The paper focus on the hydrometeorological diagnostic of a catastrophic flash flood event that affected a small semi-arid and torrential basin in Mallorca on October 2018. Rainfall evolution has been estimated from radar data, while the discharge has been obtained applying FEST-WB and the hydraulic simulation has been done through HEC-RAS. of the event and mapping of affected areas. It is an interesting case of study and a deep study that merits be published.

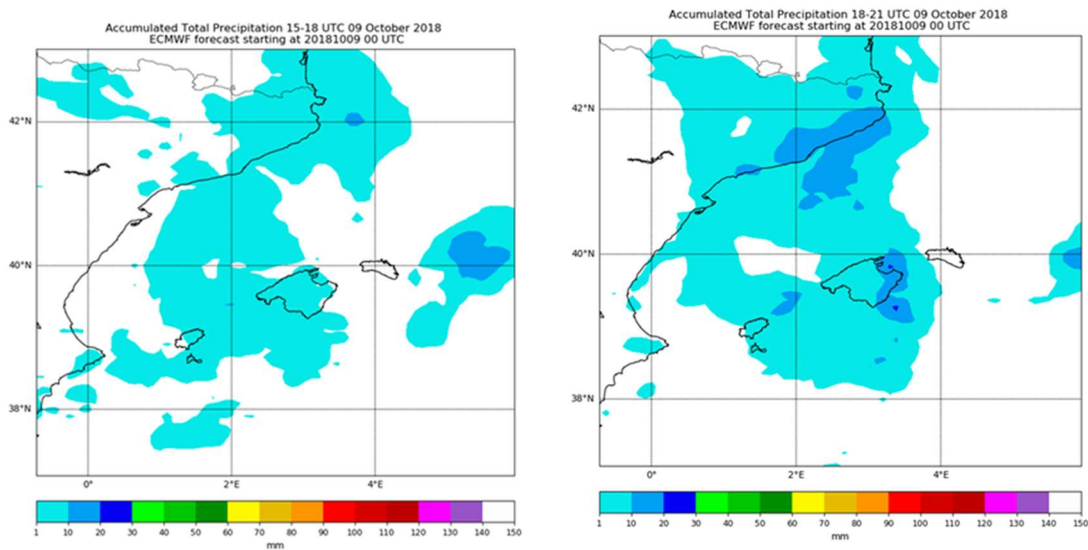
Atmospheric modelling and convective precipitation predictability The statement “An initial numerical exploratory study was performed after it was ascertained that no operational system forecasted 135 precipitation rates over eastern Mallorca anywhere near the recorded rainfall rates (Figs. 2c and 2d) in their operational cycles” is a very serious denounce that is not enough justified. As instance, authors mention Figure 2 to justify this accusation but Figure 2 shows results from WRF when the forecast made by AEMET was with another model. If you want to maintain this statement you need to be stricter and show all the operational models that you are referring.

The beginning of section 2.3 has been extended in order to provide further details on the severe underforecast of this event by the official operational models. In particular, we mention the systematic underestimations by all cycles of ECMWF and HARMONIE-AROME. As a graphical example, we show below the deterministic ECMWF forecast rainfall at 3-h intervals provided by the cycle starting at 9 October 00 UTC. We believe adding this kind of figures in the manuscript is unnecessary given the hydrologic-hydraulic main orientation of the study.
